ADDENDUM NO. 3

San Antonio Water System

Project Name: LIFT STATIONS REHABILITATION DESIGN – PHASE 3

Project No.: 08-2504

SHEET NO. **C-190-3**
26 OF 143

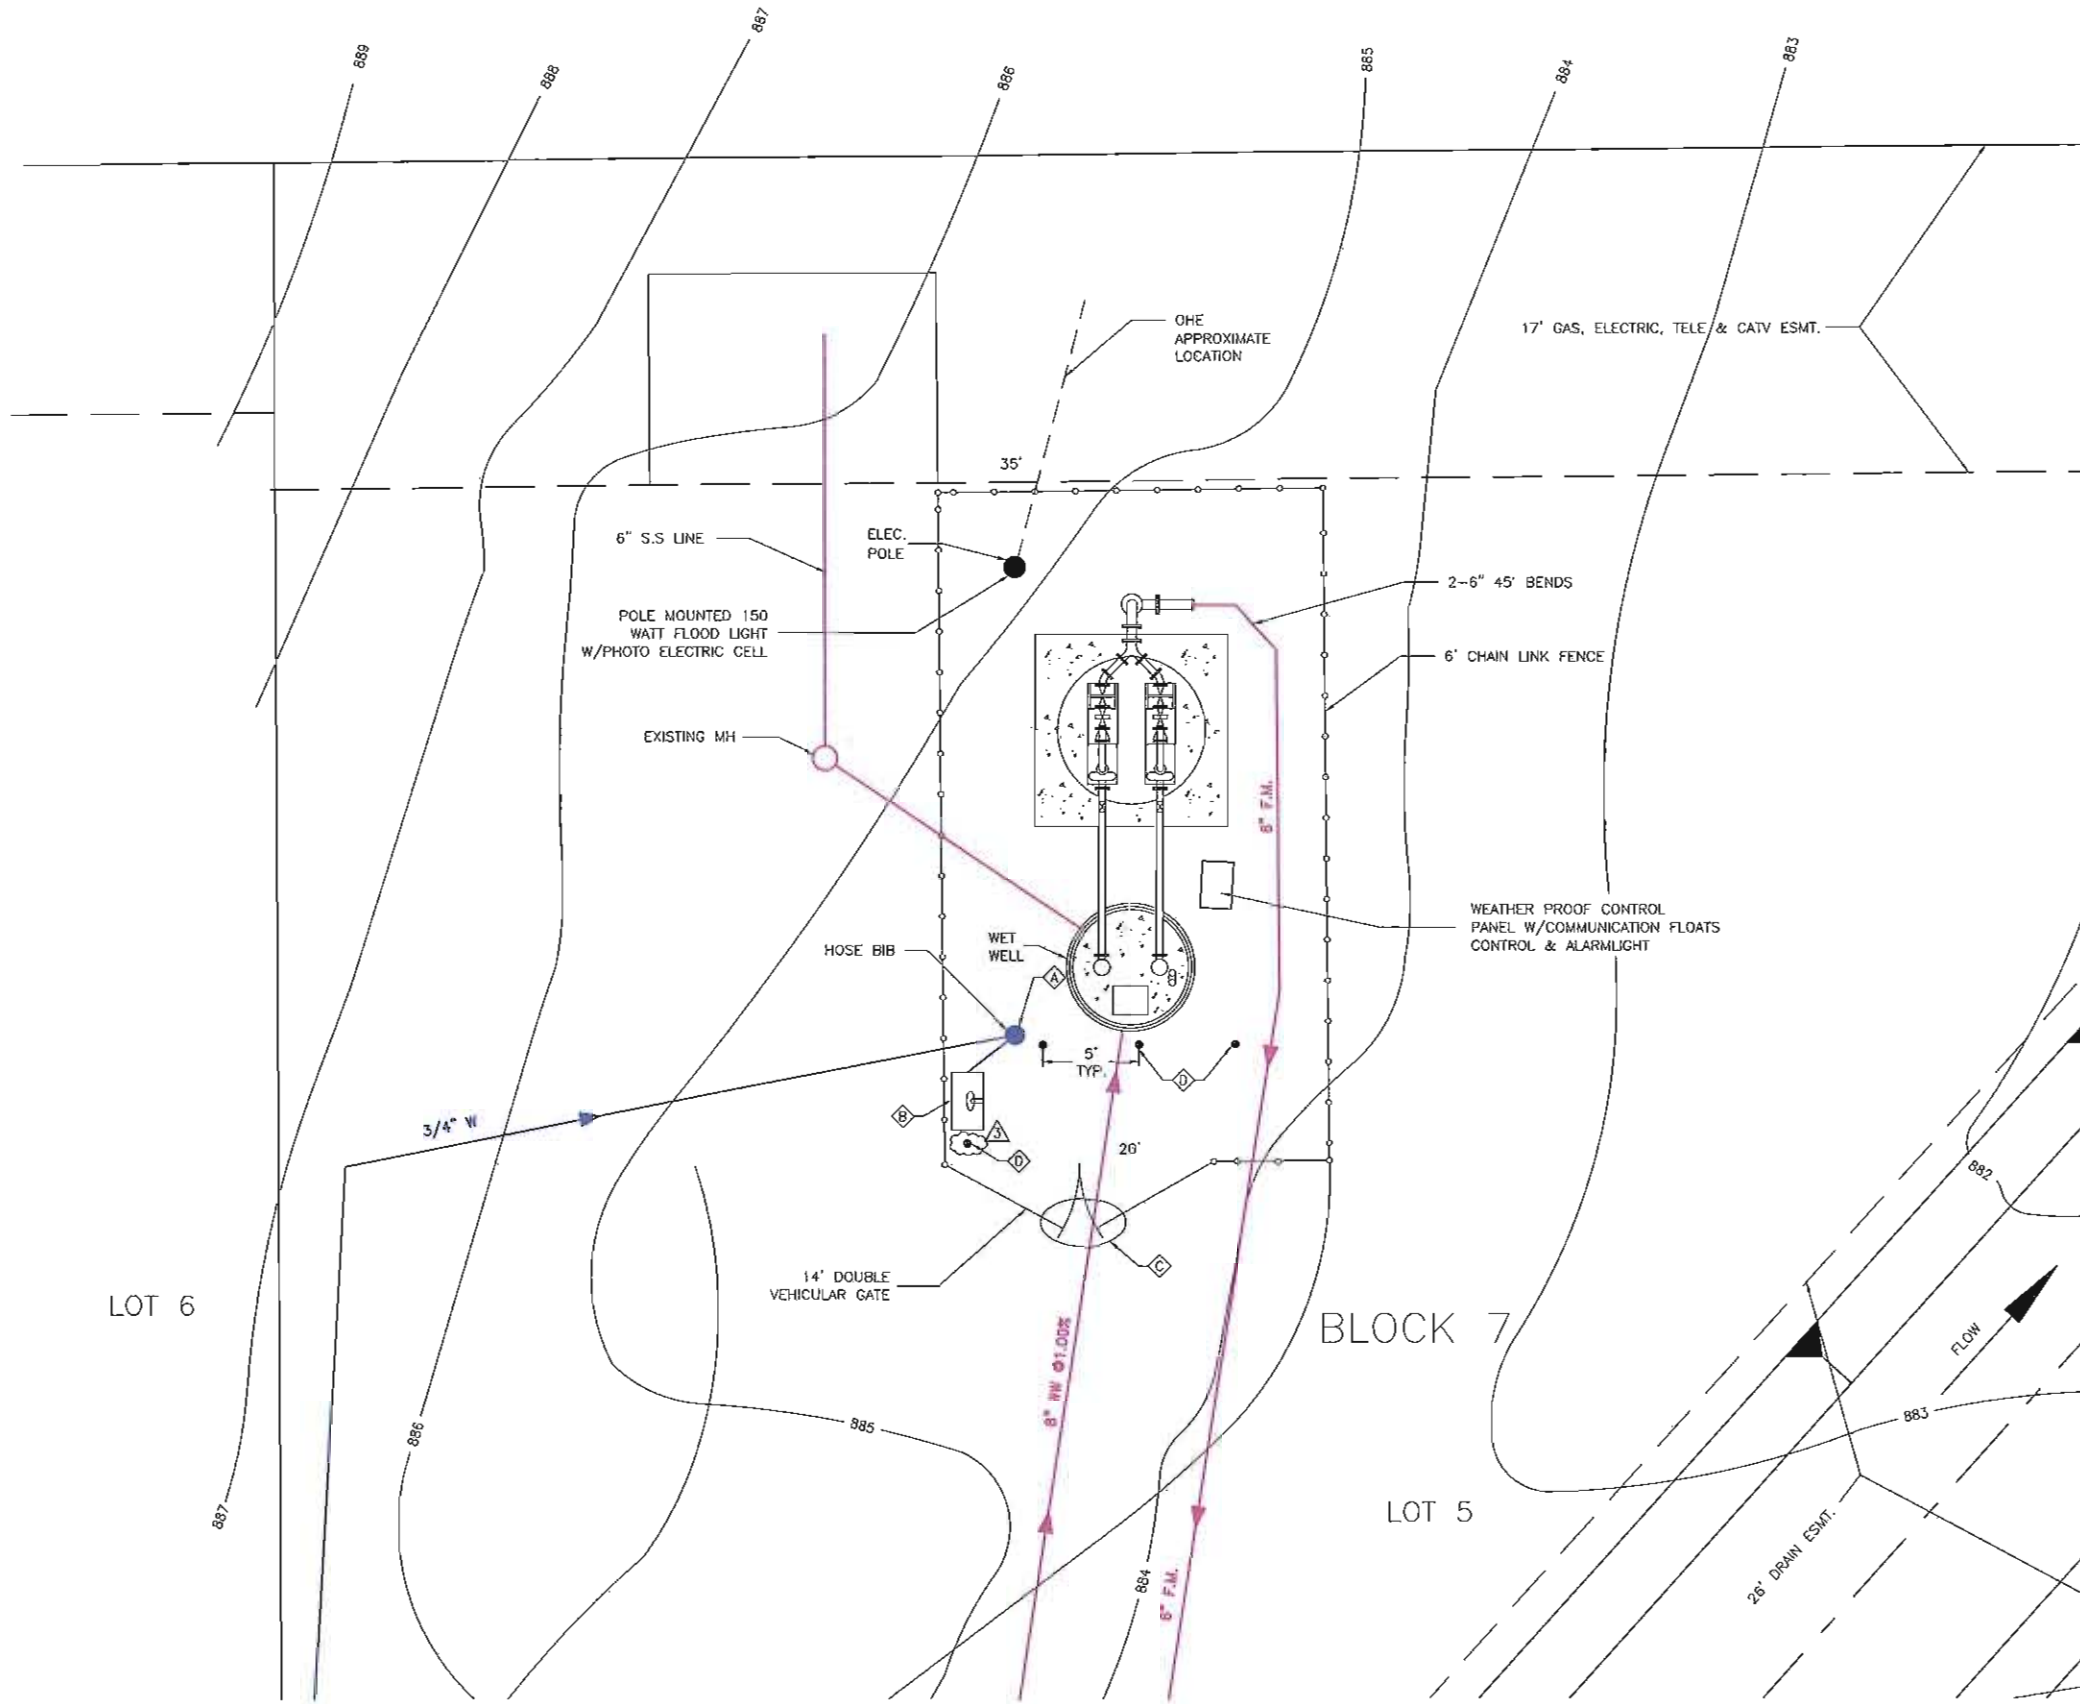
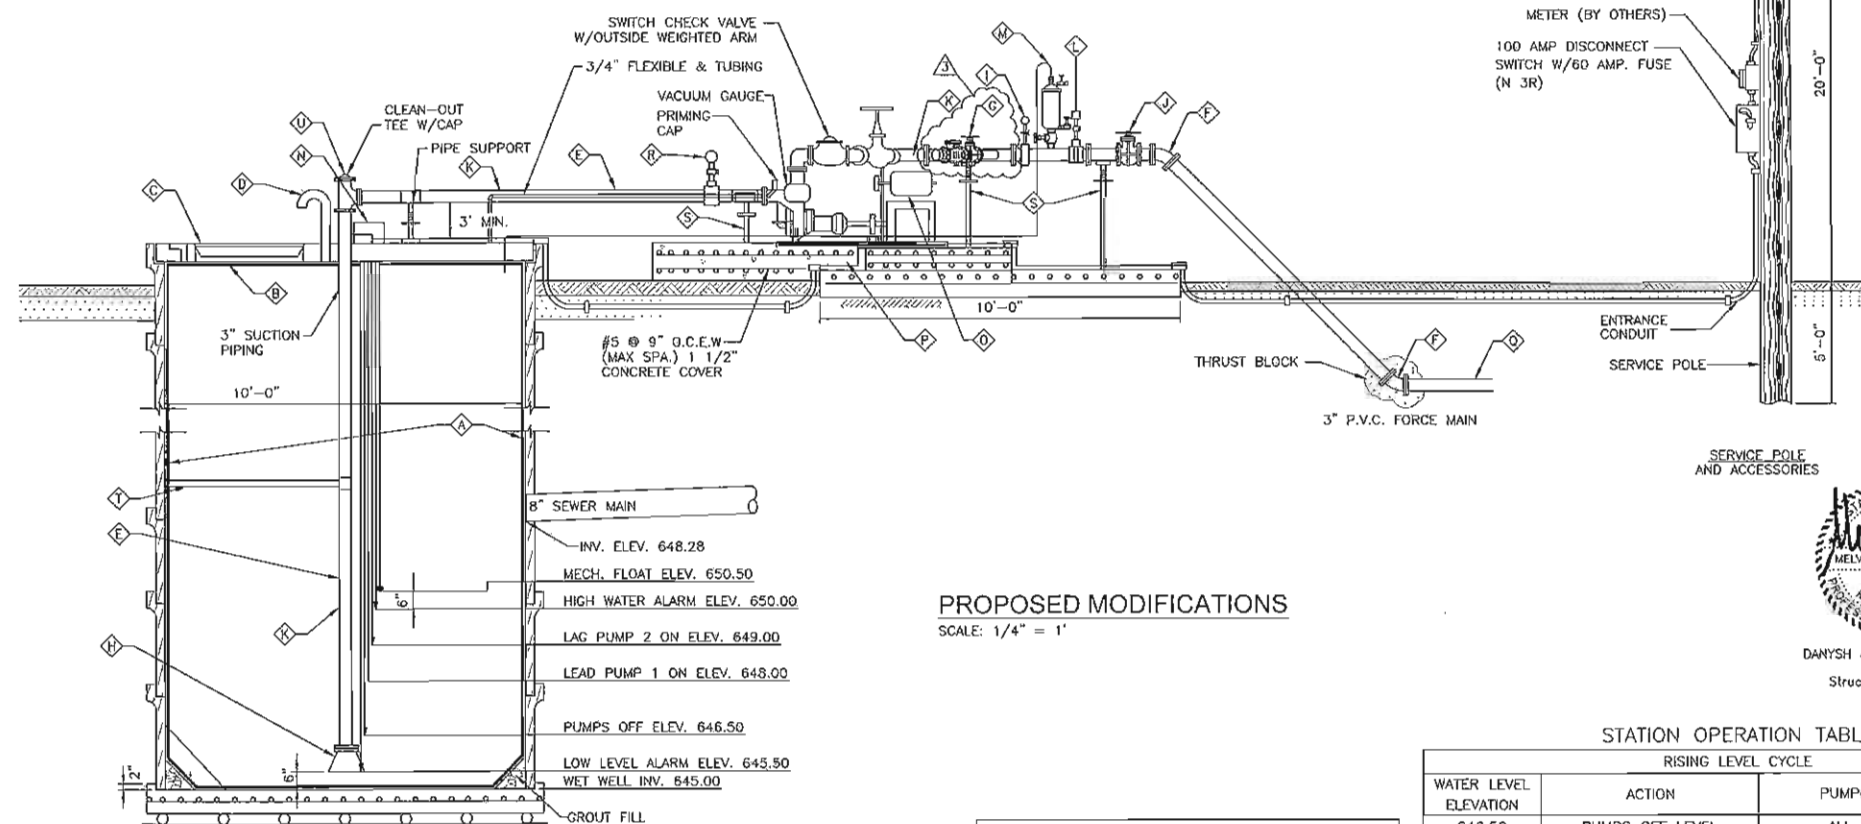
- Item 1: LS# 190 – ALAMO DOME PLAN AND SECTION VIEW**
- a) REMOVE Sheet C-190-3, Sheet 26 of 143 and REPLACE with attached revised sheet dated November 1, 2011.

Q10: On Sheet C-190-3, proposed keyed note G says to install a 4" bypass assembly with quick connect, gate valve, and check valve. However, the entire discharge line is 3" in size. Please clarify the size of the bypass assembly needed in this location.

Sheet C-190-3, proposed keyed Note G shall be revised to say install an Emergency bypass assembly with, 3" gate valve, 3" check valve, 3"x4" reducer and Quick Disconnect 4" Stainless Steel Male Fitting with Dust Cap.

NOTES	INITIALS	DATE
DESIGNED BY	CC	11/01/11
REVIEWED BY	AL	11/01/11
SCALE:	AS SHOWN	
SHEET NO.	E-205-2	
	33 OF 143

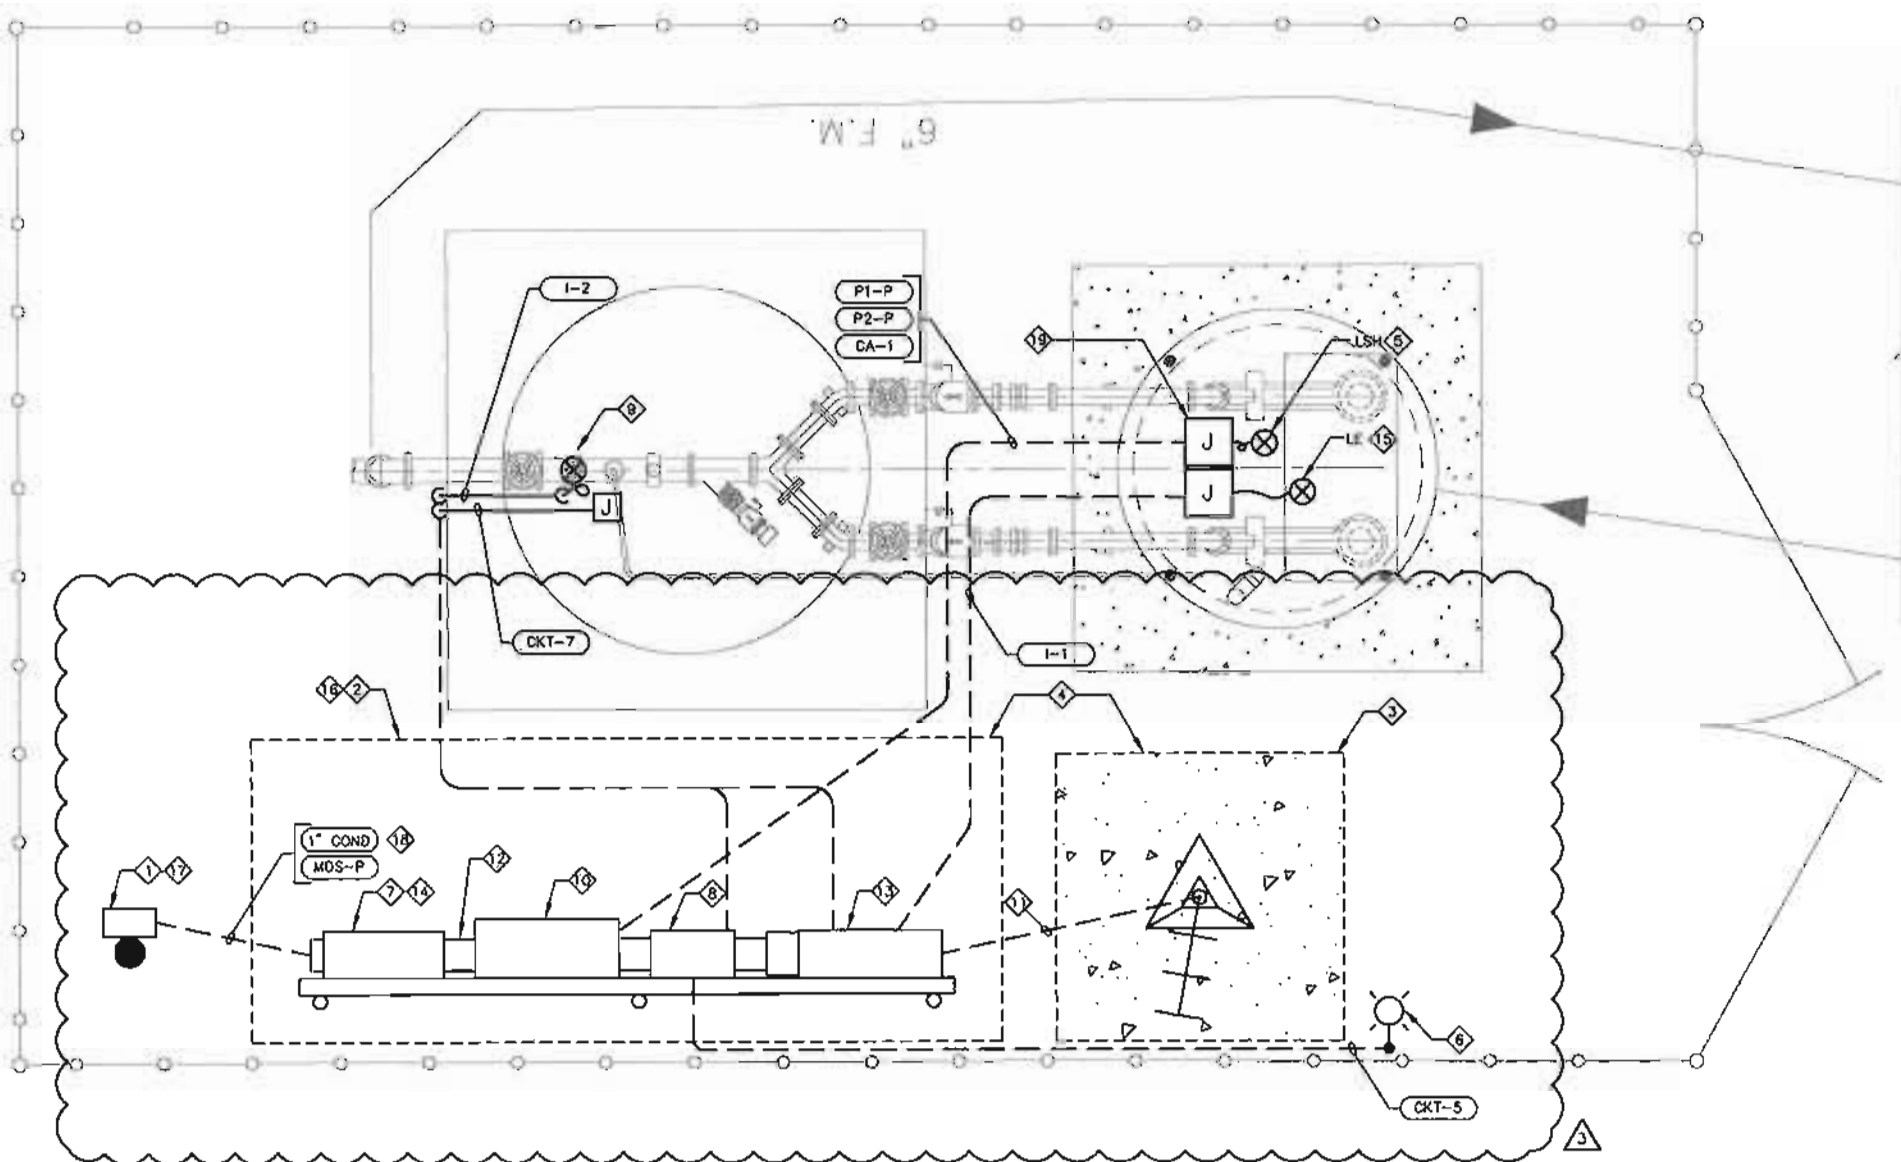
- a) REMOVE Sheet E-205-2, Sheet 33 of 143 and REPLACE with attached revised sheet dated November 1, 2011.
- Item 4: LS# 210 – HORSESHOE BEND PLAN AND SECTION VIEW**

LIFT STATIONS REHABILITATION DESIGN - PHASE 3
LS# 245 - HARRIS MIDDLE SCHOOL
PLAN AND SECTION VIEW

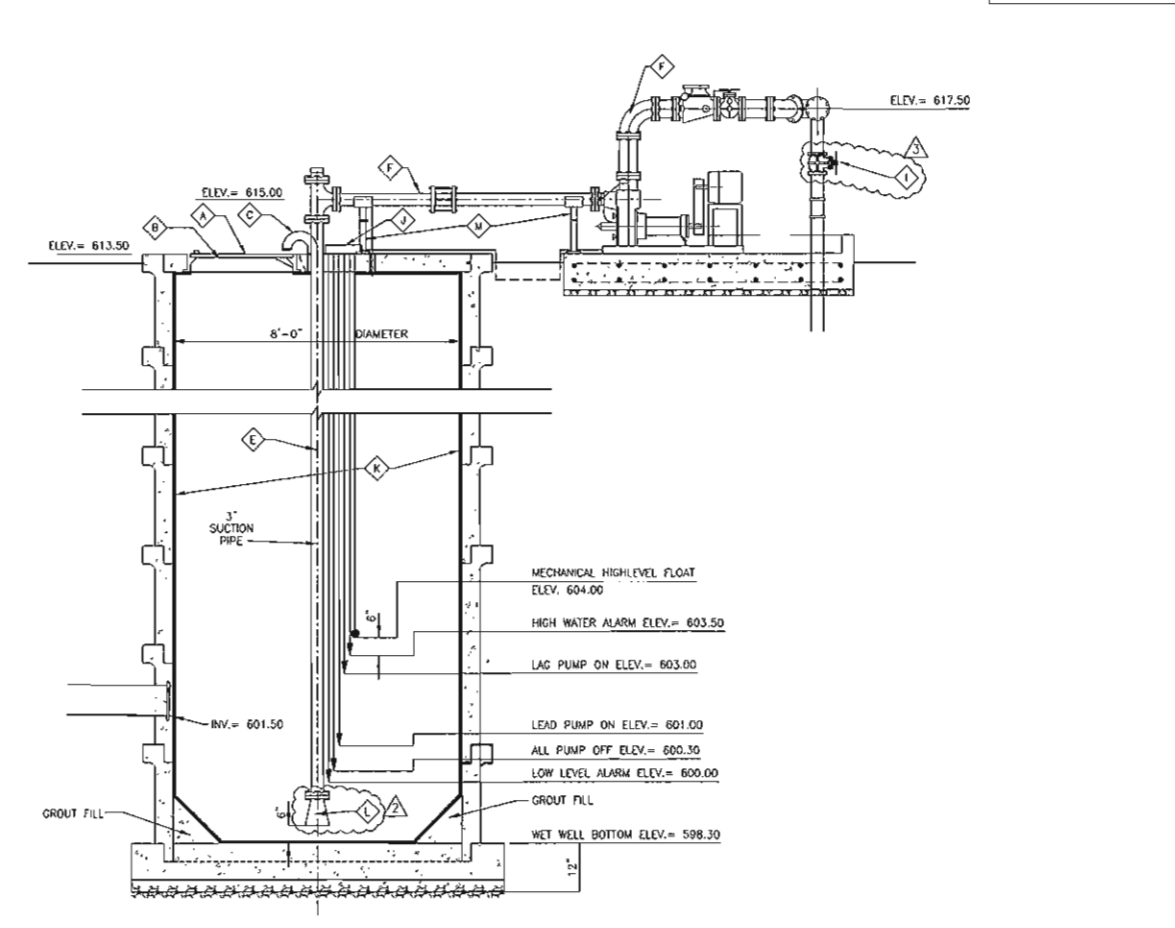
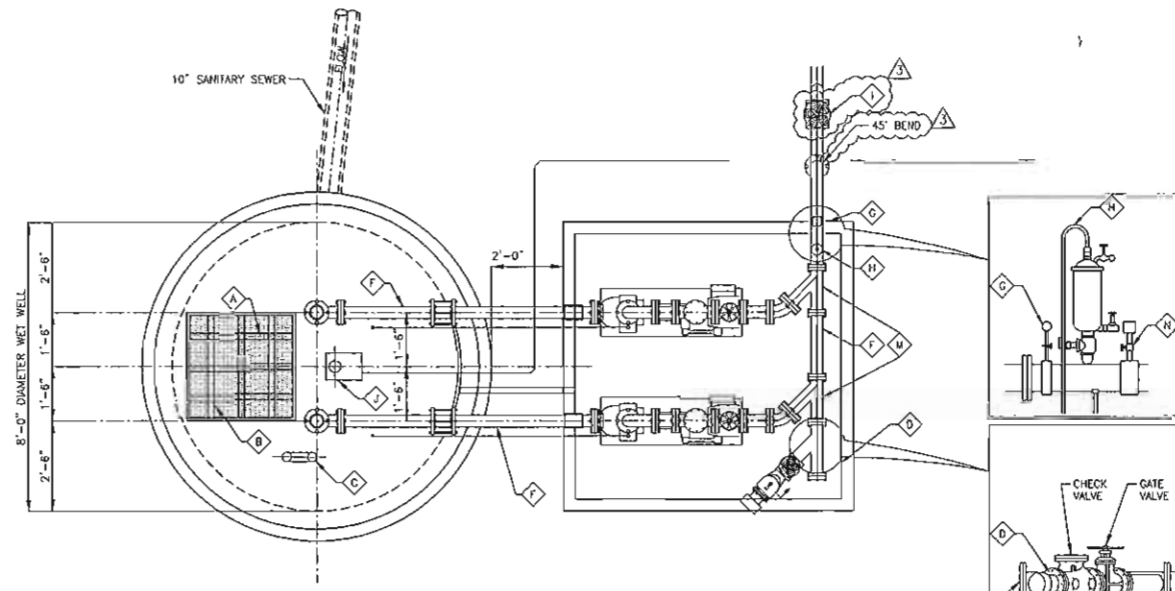
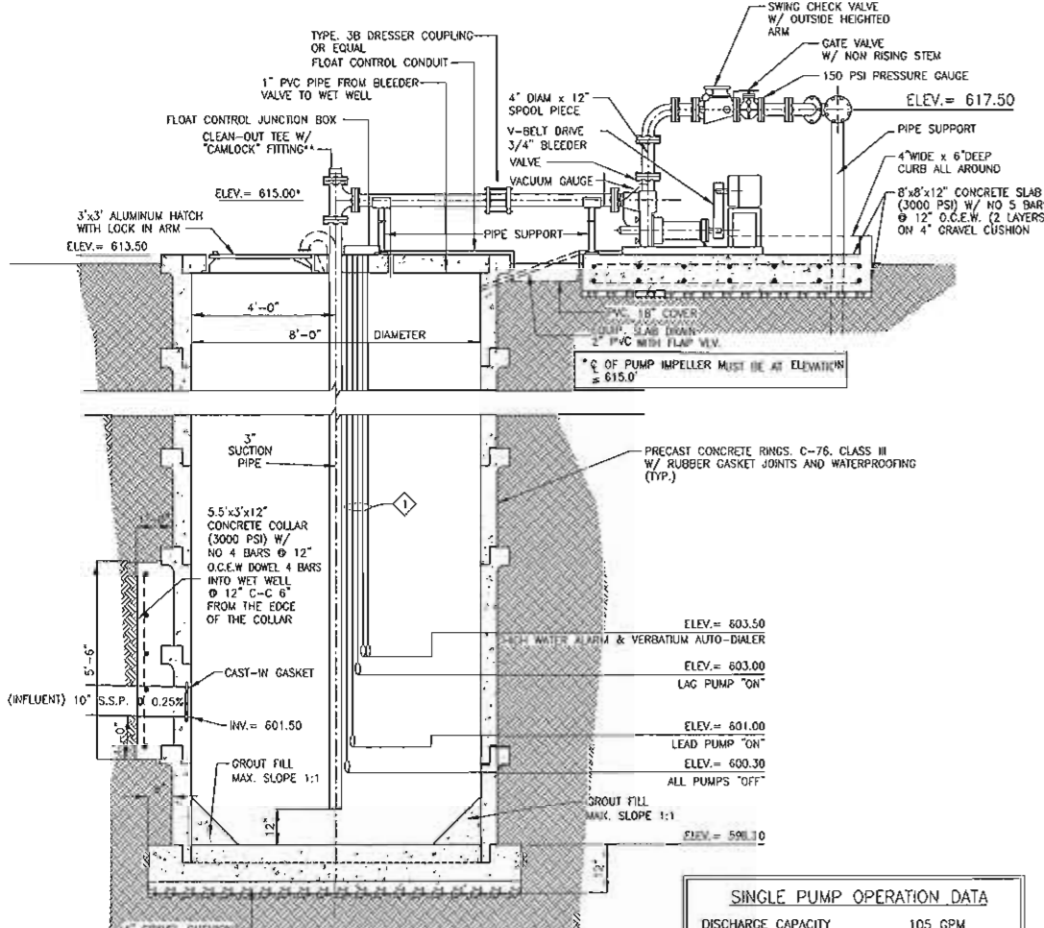
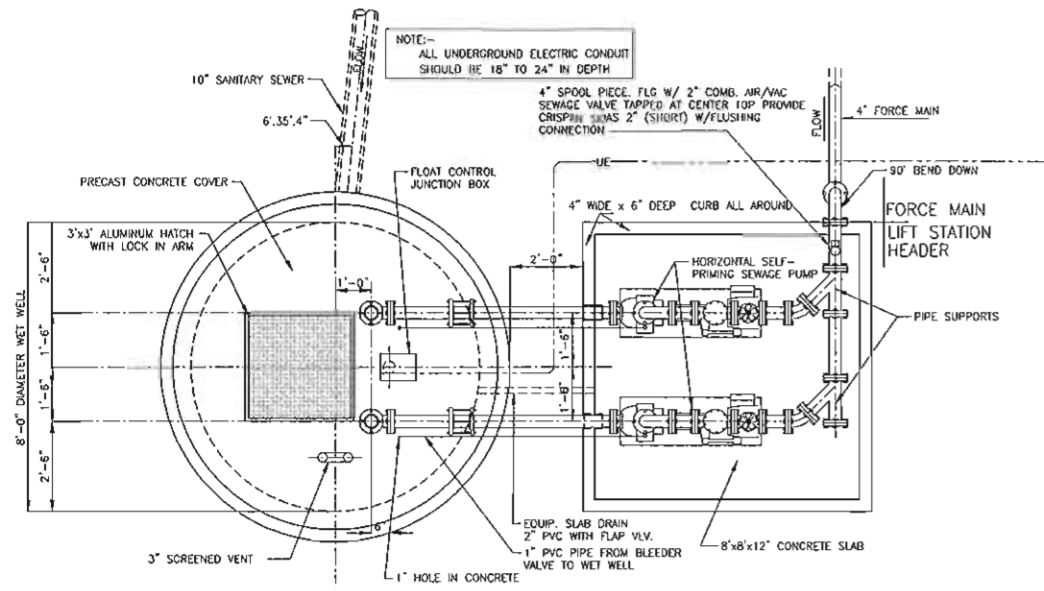
- b) Sheet E-239-3, change text on generator breaker from "2P-200A" to "3P-200A".
- Item 8: LS# 245 – HARRIS MIDDLE SCHOOL PLAN AND SECTION VIEW**
- a) REMOVE Sheet C-245-2, Sheet 67 of 143 and REPLACE with attached revised sheet dated November 1, 2011.

Q11: On Sheet C-245-2, proposed keyed note I says to install a 4" gate valve. The plan view shows a 4" gate valve before the 90 degree bend in to the ground, but the section view shows a 4" gate valve after the 90 degree bend in to the ground.
